HOWARD COUNTY DEPARTMENT OF PLANNING AND ZONING

F-98-42

Buckskin Lake Overlook

BUCKSKIN LAKE OVERLOOK
LOTS 5, 6 AND
PRESERVATION PARCEL 'A'
(A RESUBDIVISION OF J. DAVID MULLINIX PROPERTY -
LOT 4; PLAT NO. 8658 THRU 8660)

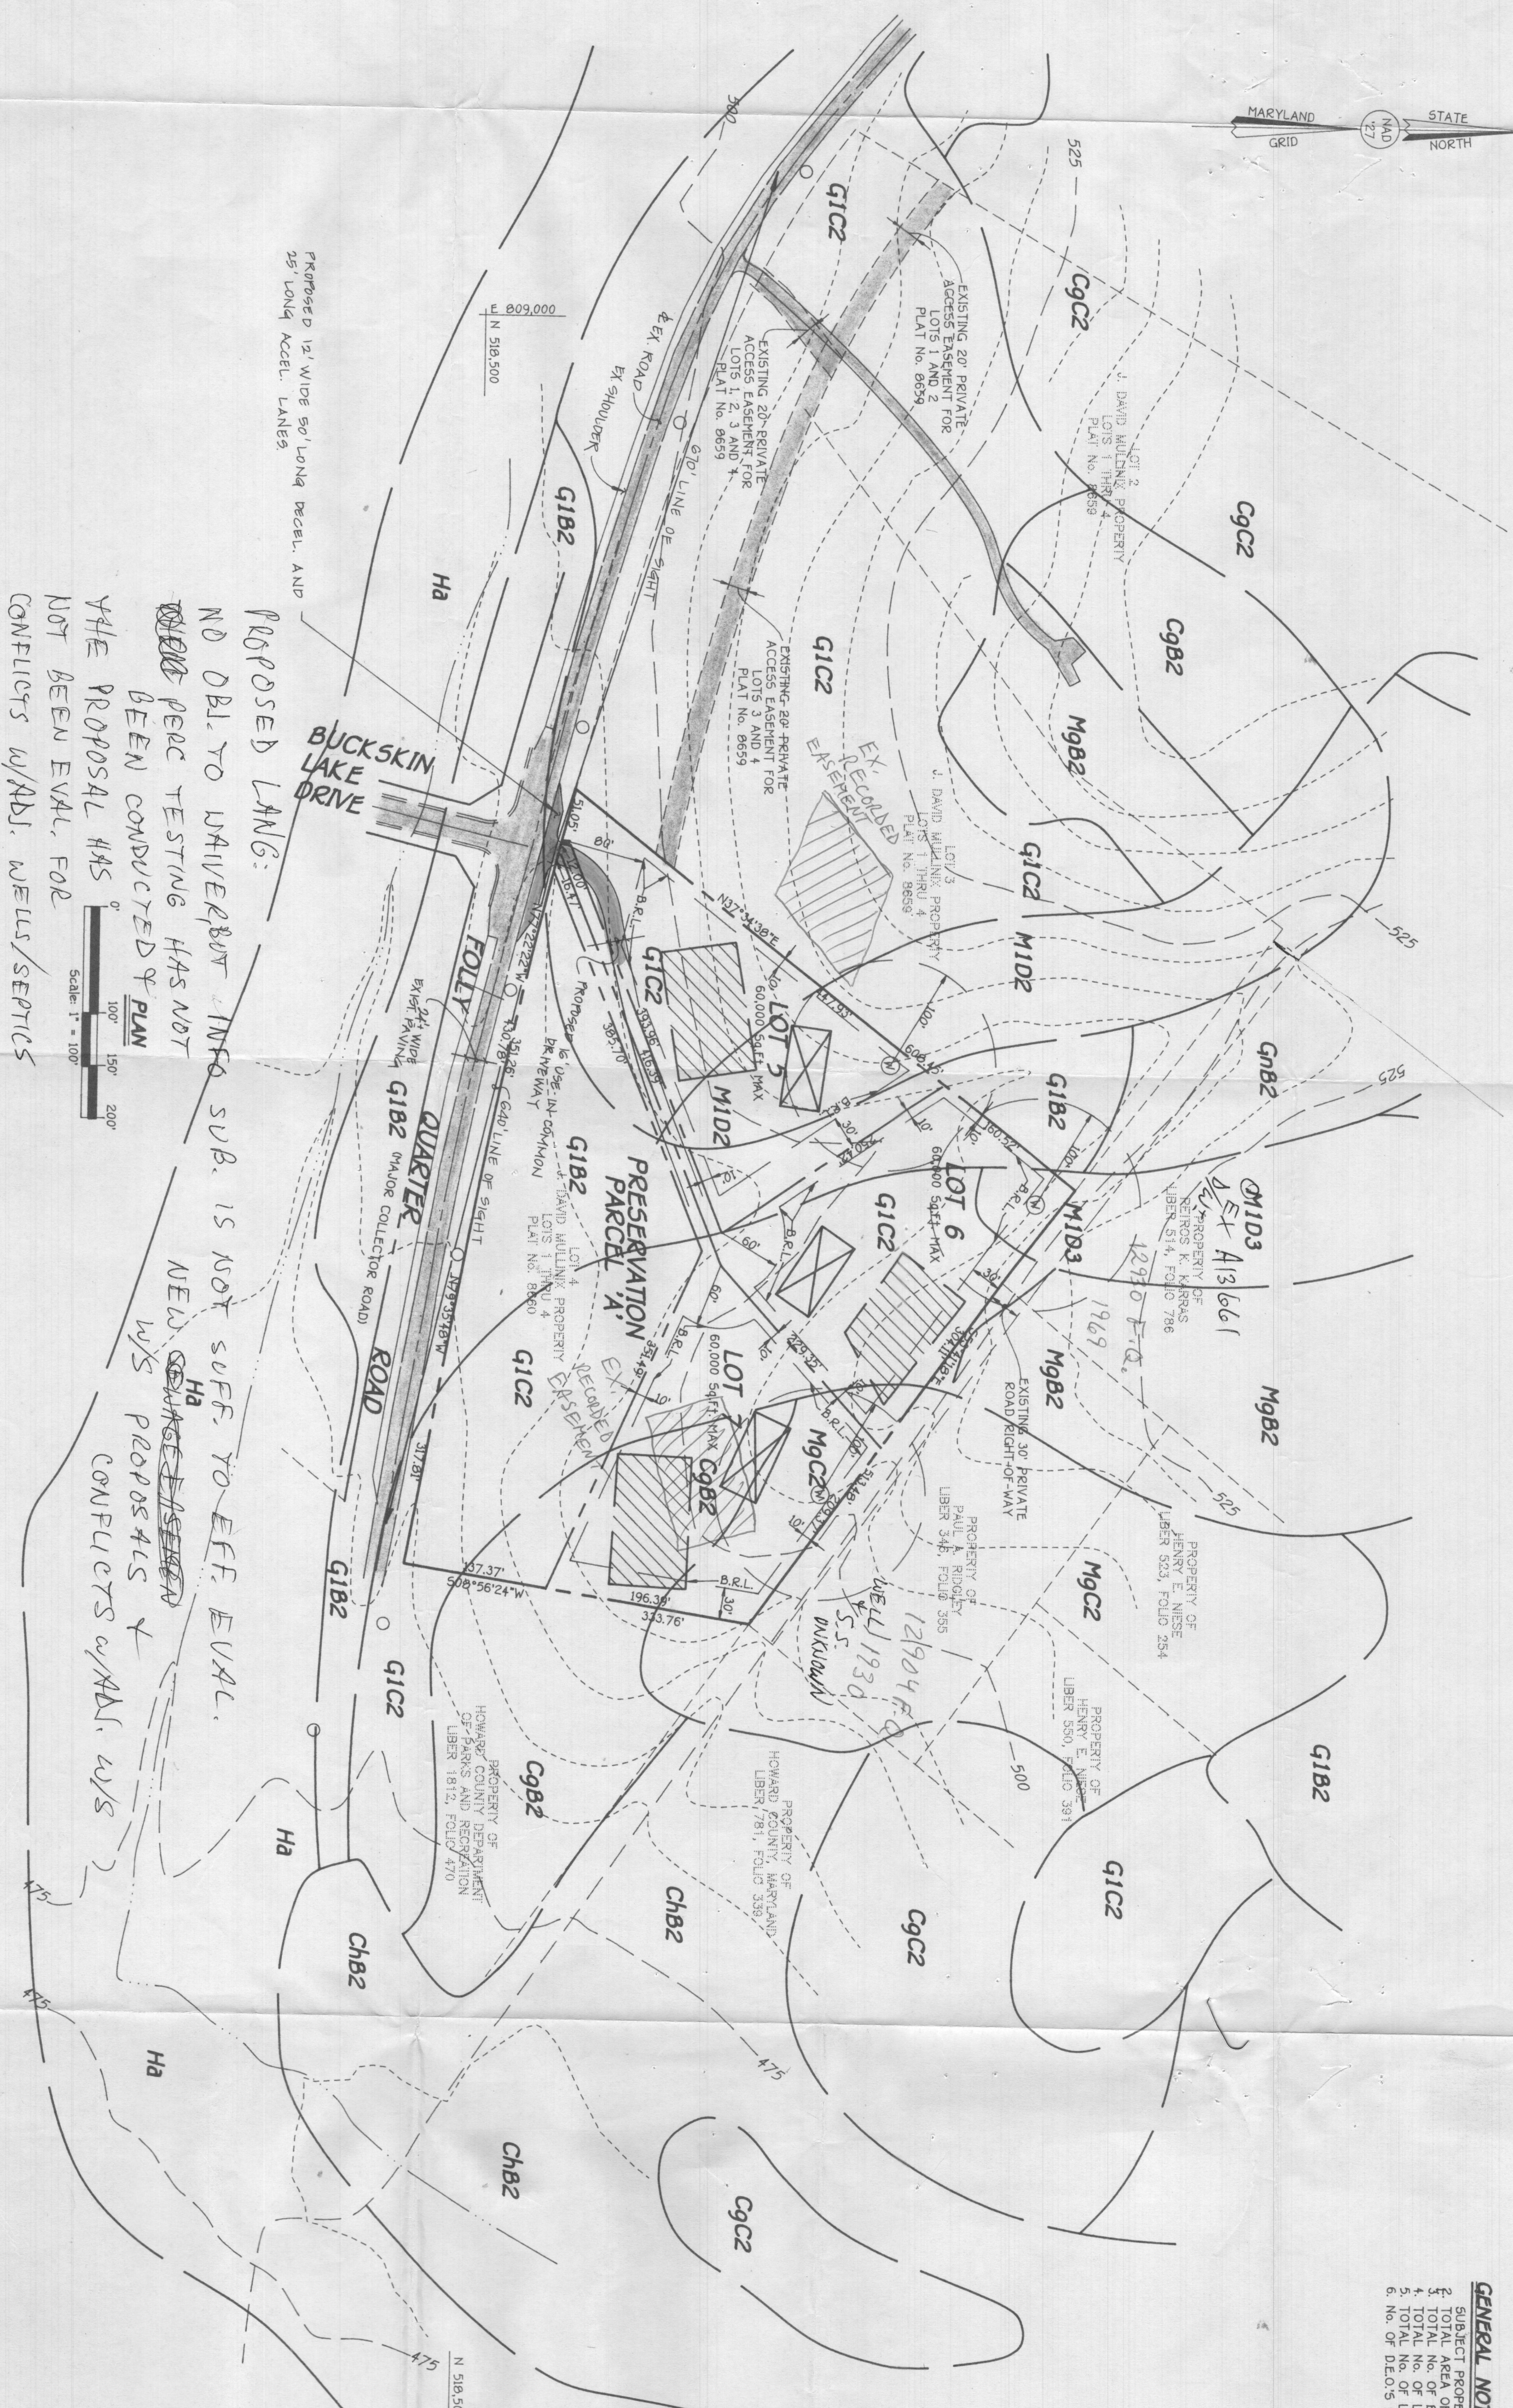
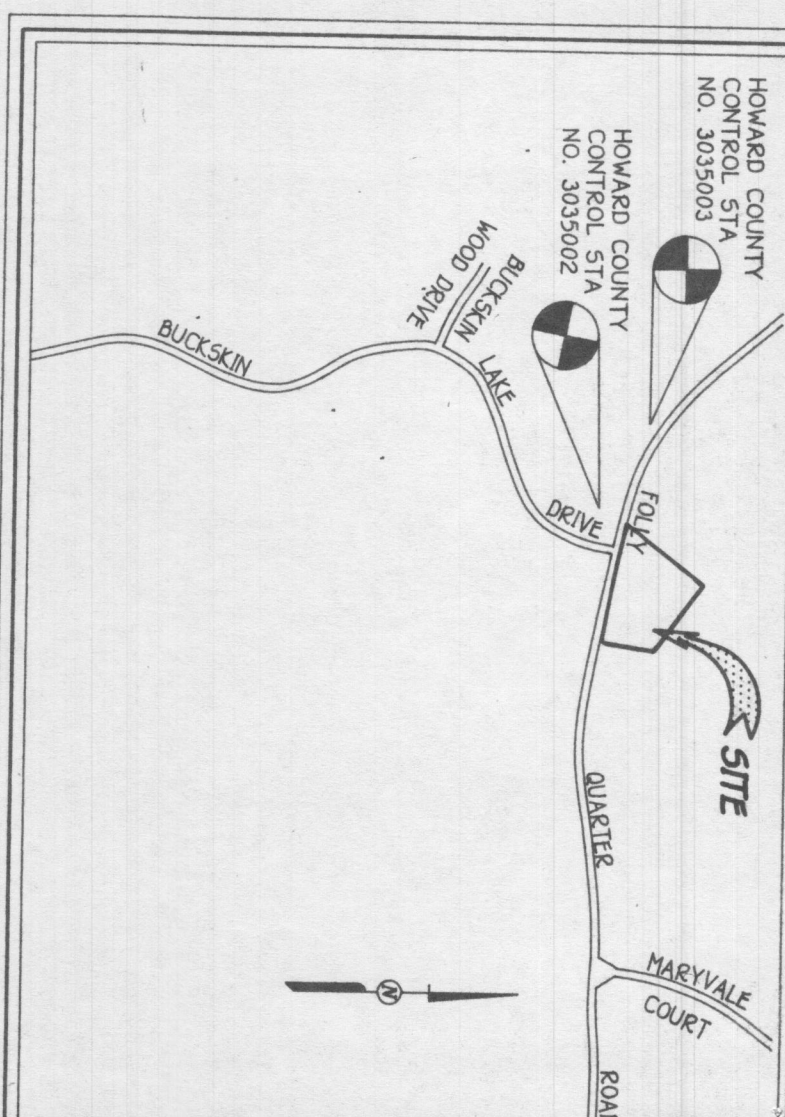
PROPOSED LANE:
NO DBL TO UNIVERBIT INFO SUB. IS NOT SUFF. TO EFF. EVAL.
BEEN CONDUCTED HAS NOT
YET PROPOSAL HAS NOT
NOT BEEN EVAL. FOR
CONFLICTS W/ADS, WELLS, SEPTICS

NEW ~~CONTRACT PURCHASE~~
W/S PROPOSALS &
CONFLICTS W/ADS, W/S

BUCKSKIN LAKE OVERLOOK
LOTS 5 THRU 7 AND
PRESERVATION PARCEL 'A'
ZONED: RR-DEO
LOT 4: PLAT NO. 8658 THRU 8660
THIRD ELECTION DISTRICT
HOWARD COUNTY, MARYLAND
TAX MAP NO. 22 PARCEL NO. 73

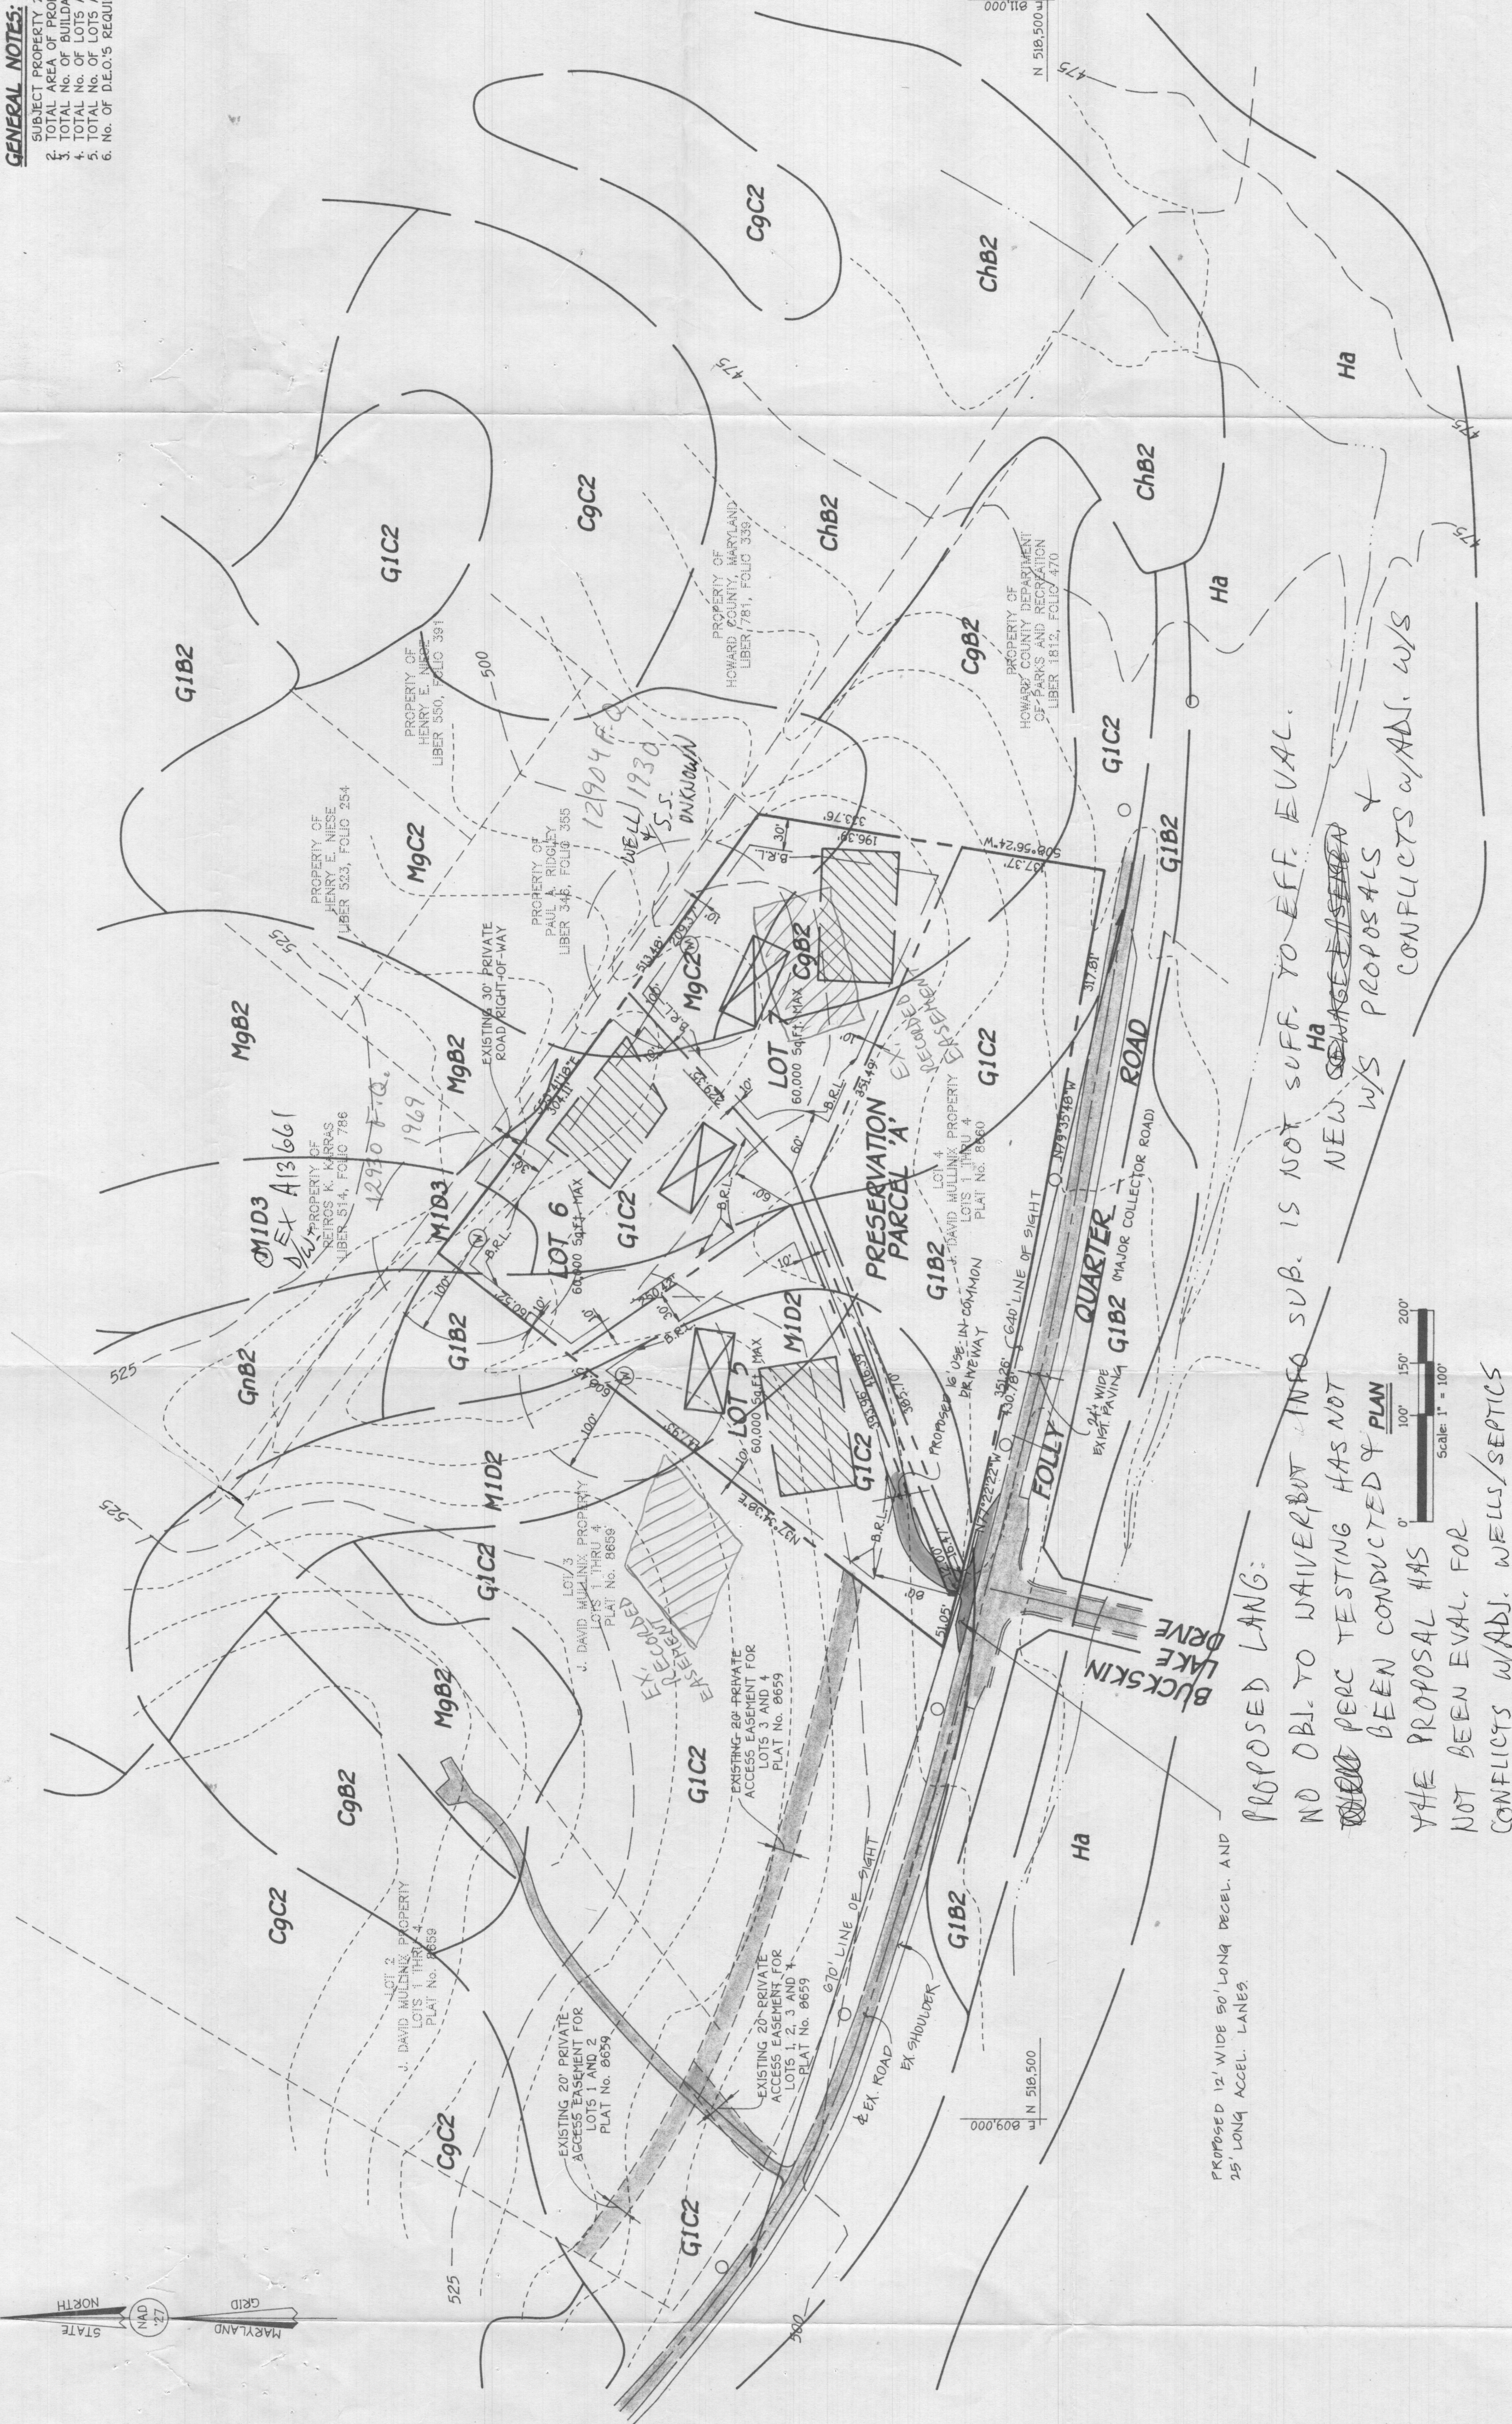
PROPOSED LANG:
NO DBL TO WAIVER BUT INFO SUB. IS NOT SUFF. TO EFF. EVAL.
PERC TESTING HAS NOT
BEEN CONDUCTED & PLAN
THE PROPOSAL HAS
NOT BEEN EVAL. FOR
CONFLICTS W/ADJ. WELLS/SEPTICS

NEW ~~SEWAGE~~ PROPOSALS
W/S PROPOSALS
CONFLICTS w/ADJ. W/S
